REQUEST FOR INFORMATION	DATE: March 29, 2017	NO.: RFI-501
--------------------------------	-----------------------------	---------------------

Project Name: 15051-Webster University Interdisciplinary Science Building

Subject: Vacuum Pump Exhaust Vent and Natural Gas Venting Locations

BUILDING SECTIONS

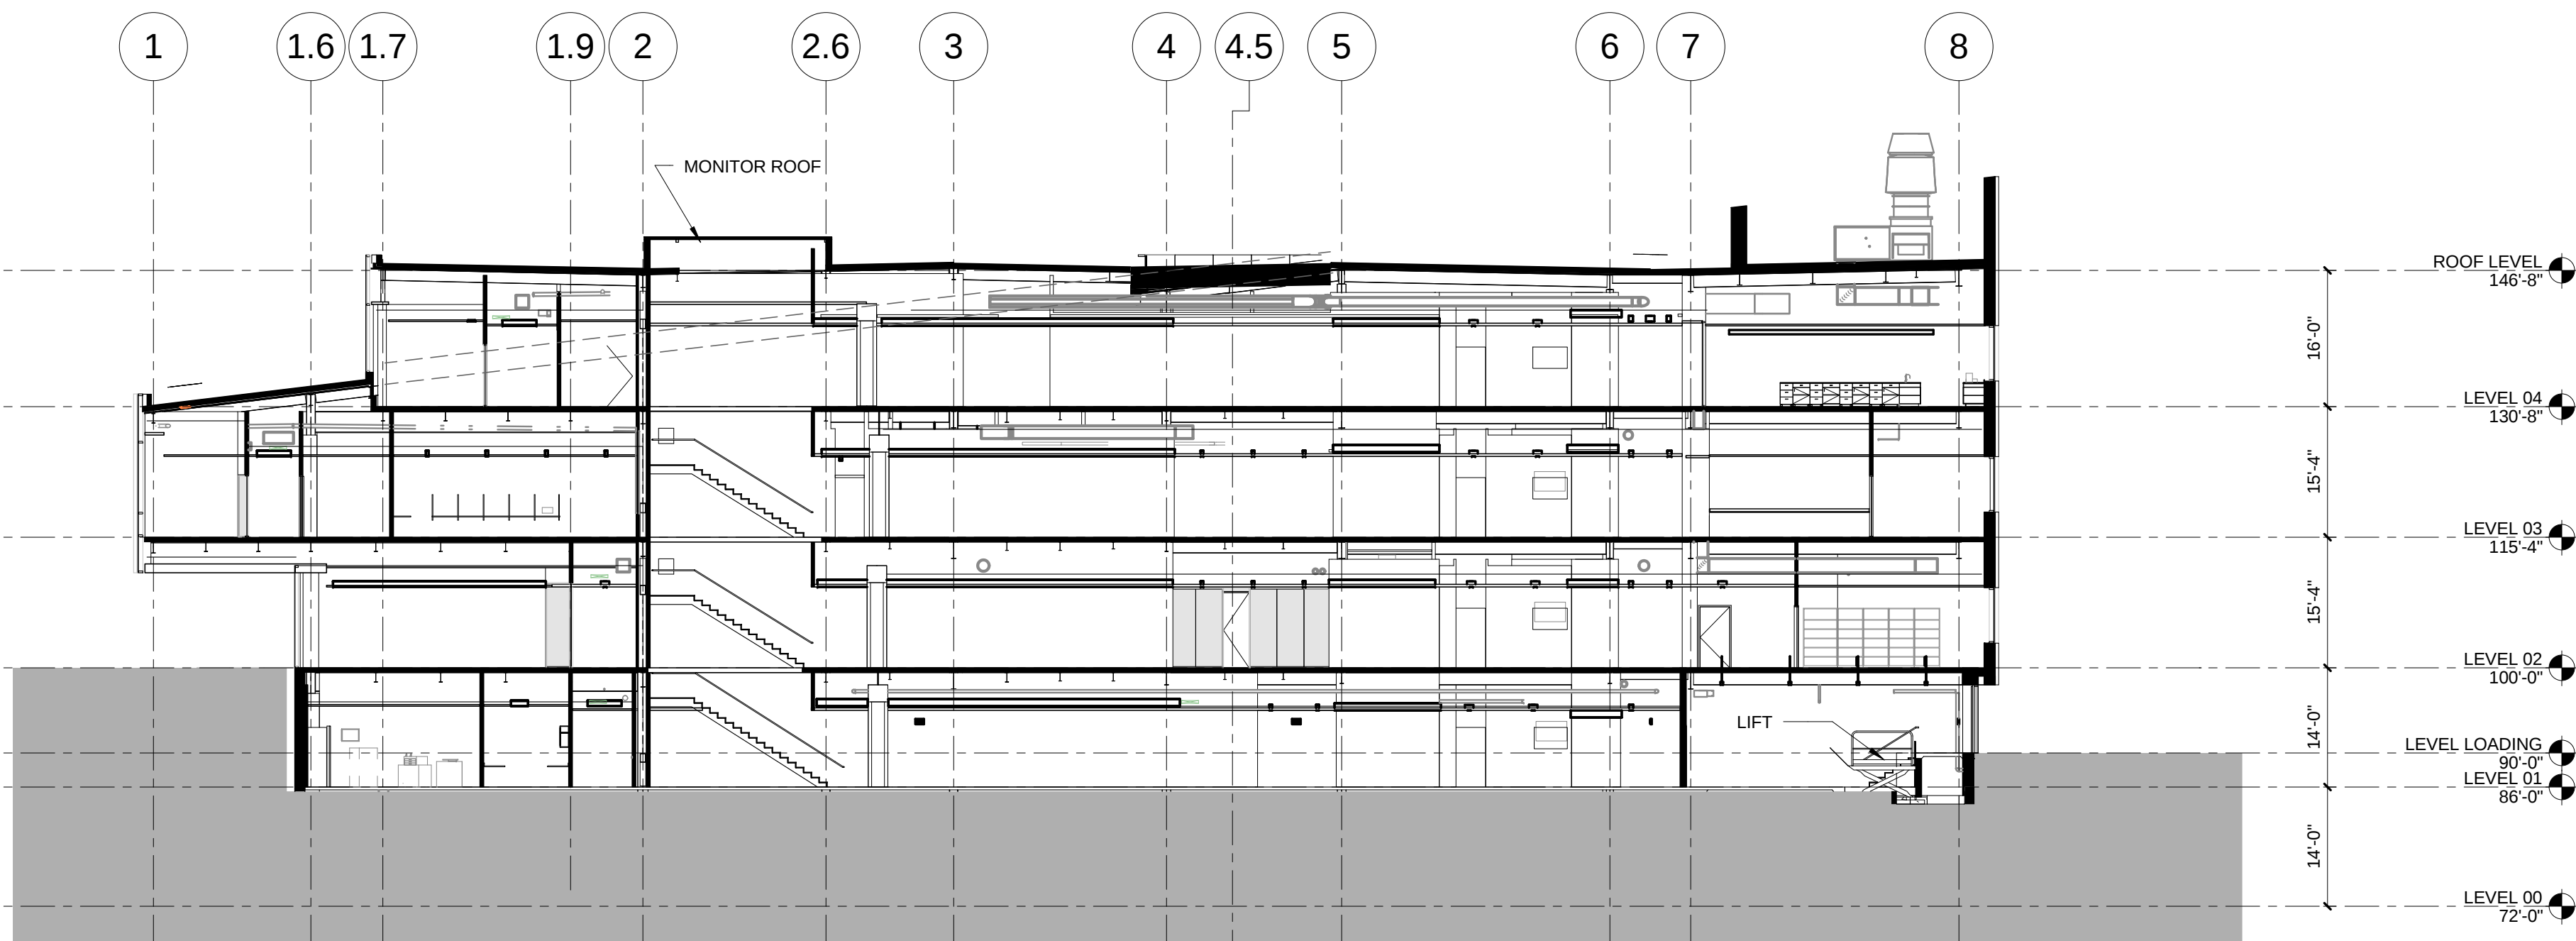
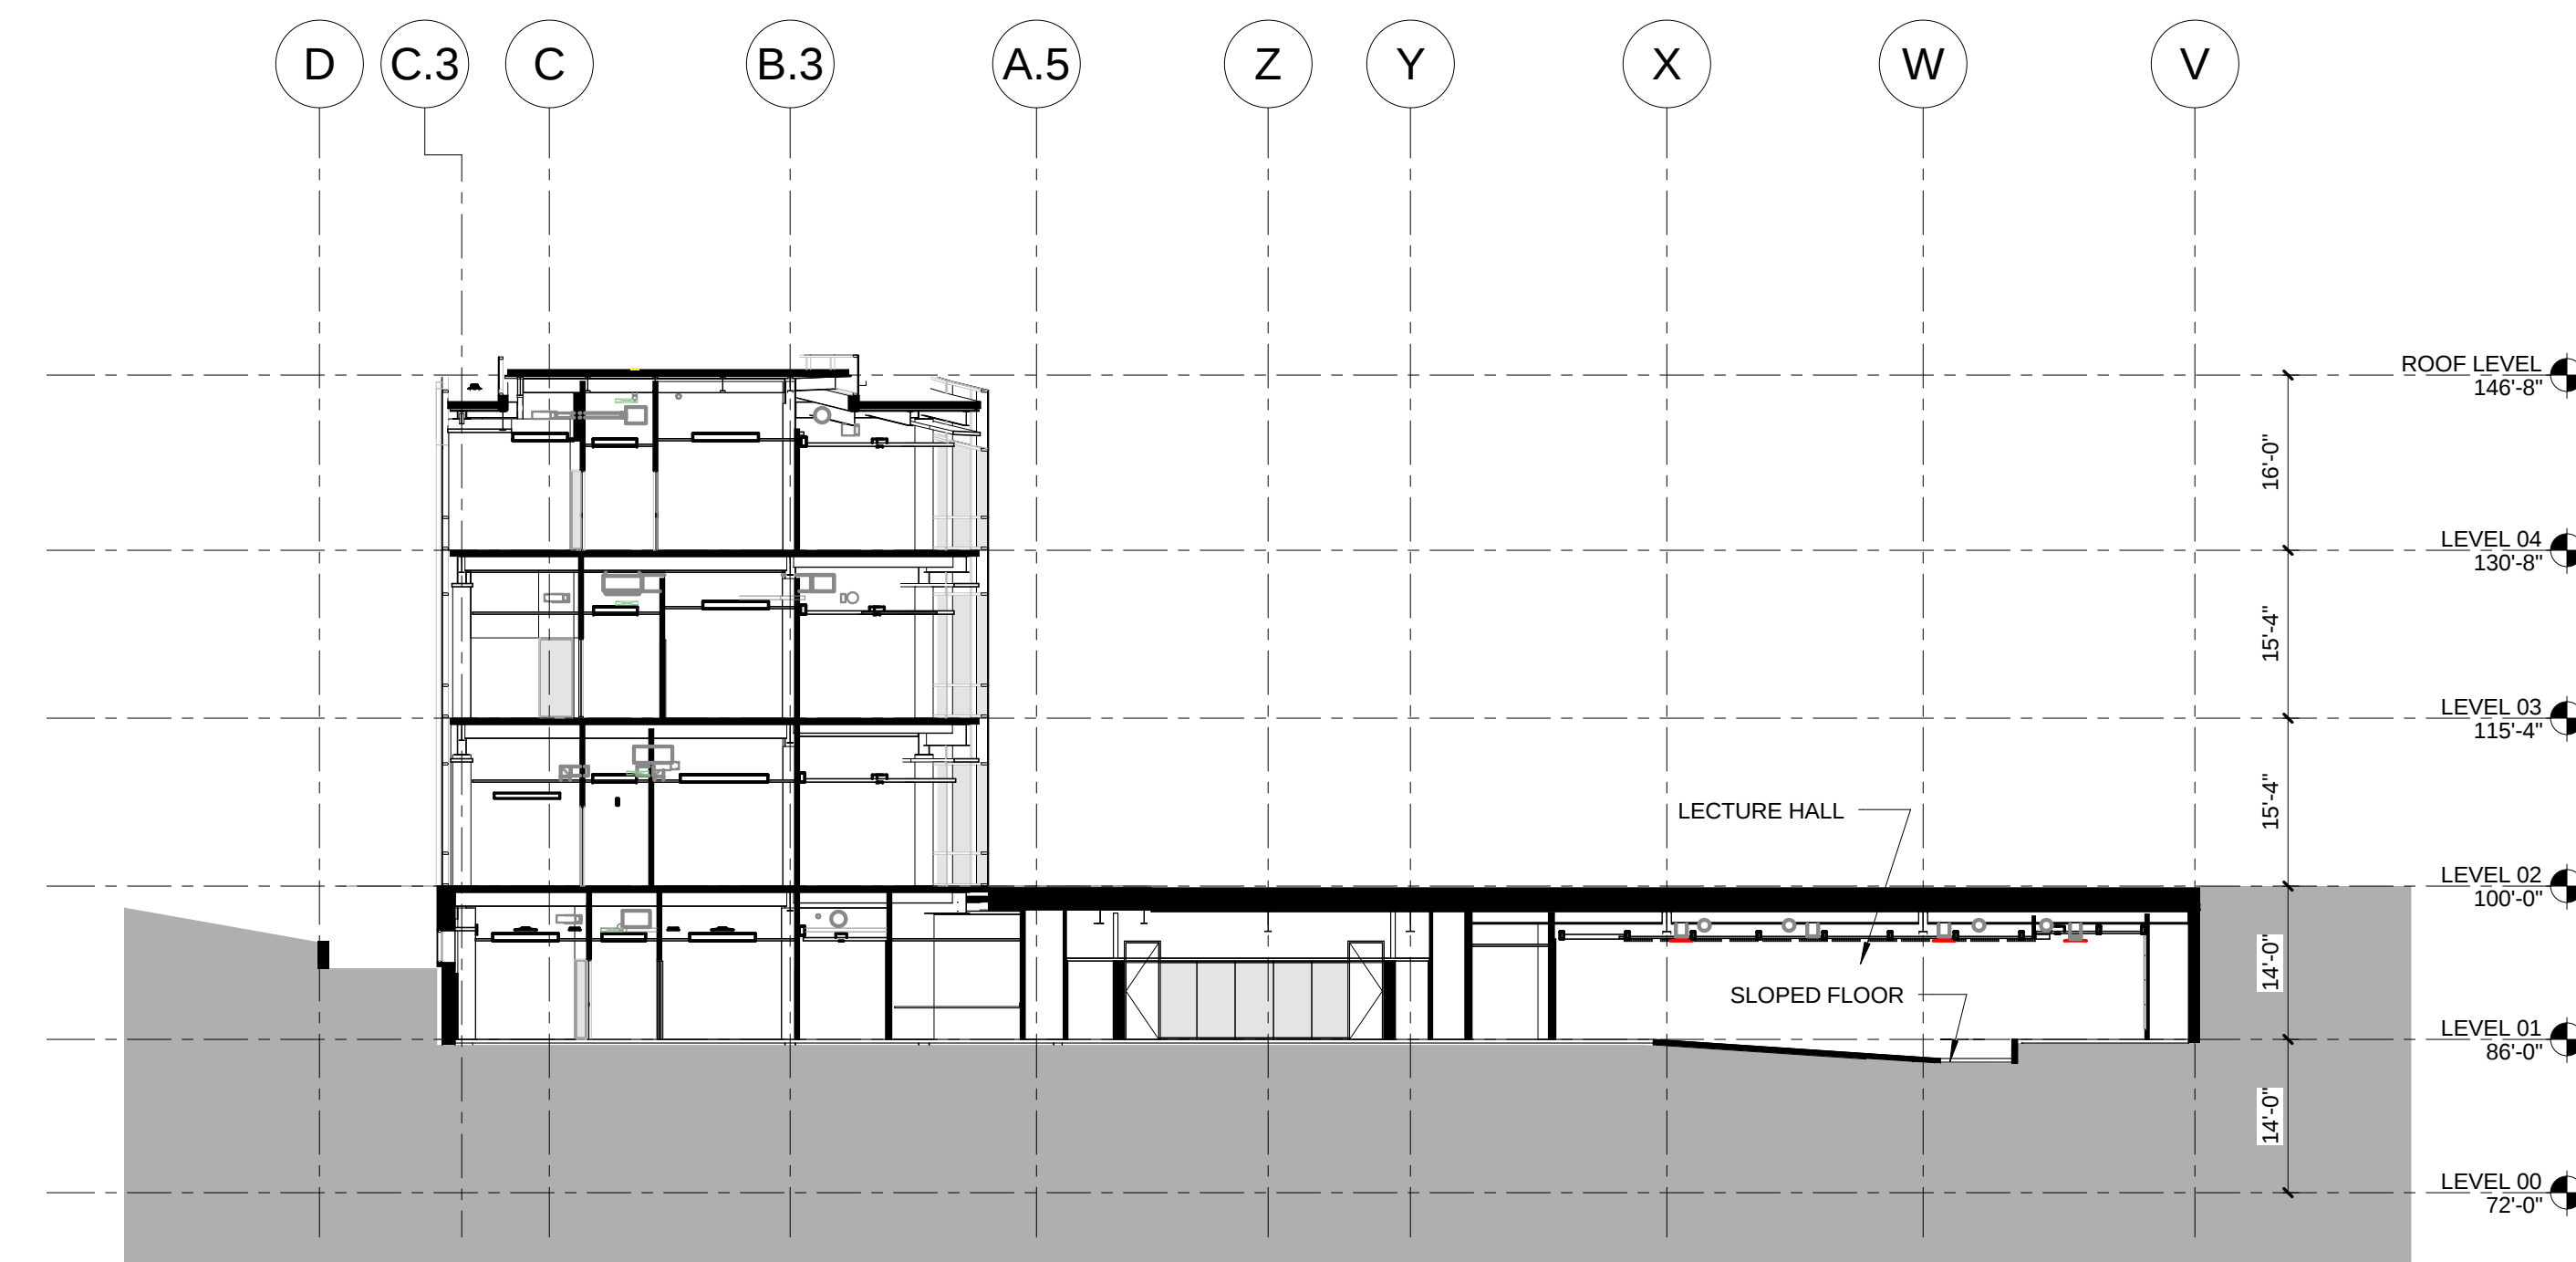
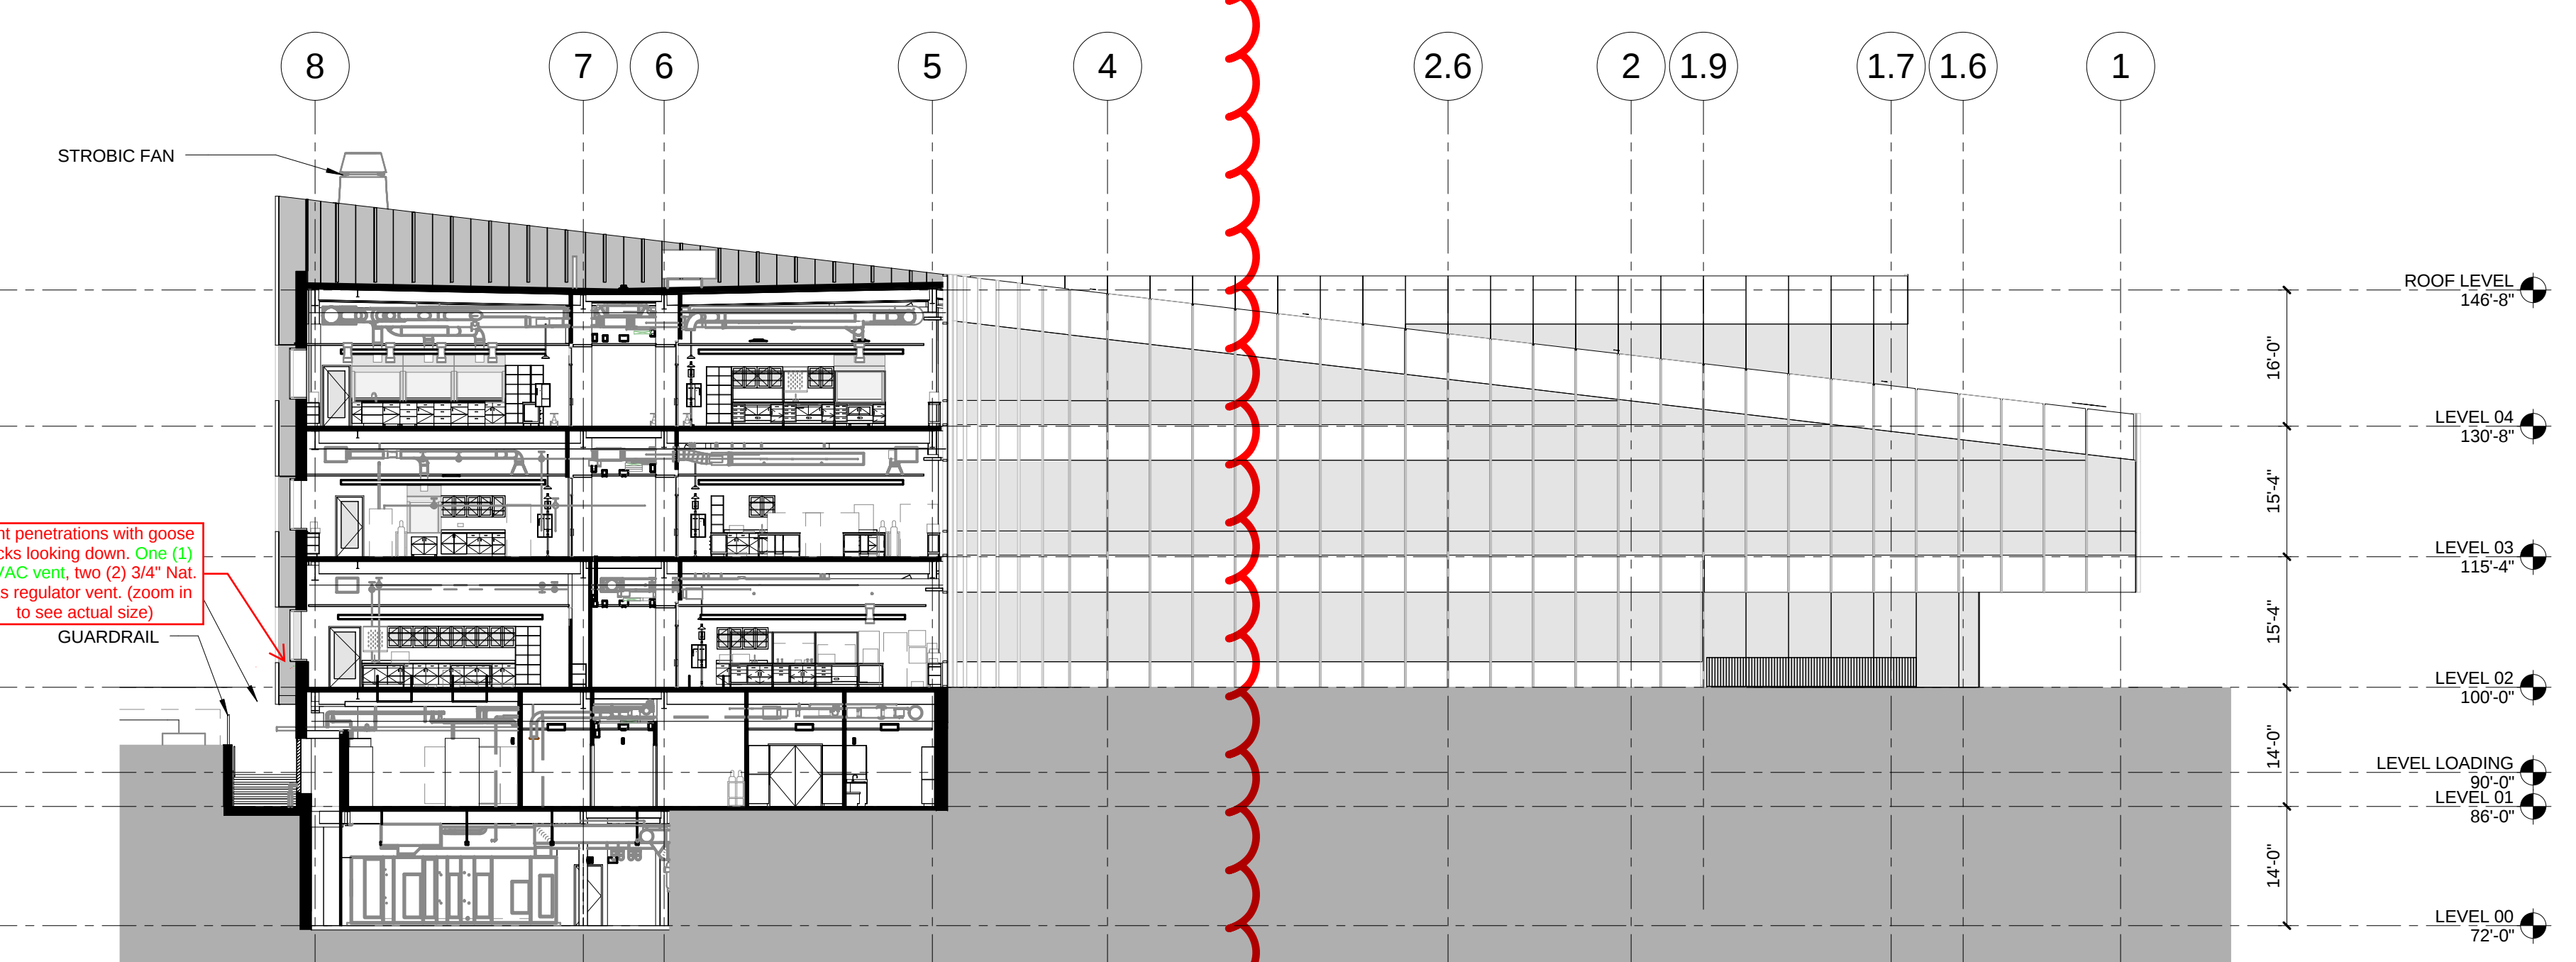
Proposed natural gas and vacuum pump exhaust vent locations are attached. Locations chosen to follow applicable code (below) and to be concealed as much as possible. Vents will be between 6' and 10' above intake louver. All three vents will turn down to prevent water/debris infiltration.

Contractor proposed vent pipe discharge locations appear to be acceptable to WTA and meet the intent of the Code. Contractor to properly install any dissimilar metals to avoid galvanic corrosion. Architect has requested vent pipes to be painted to match the exterior of the building. Coordinate color and final location with Architect.
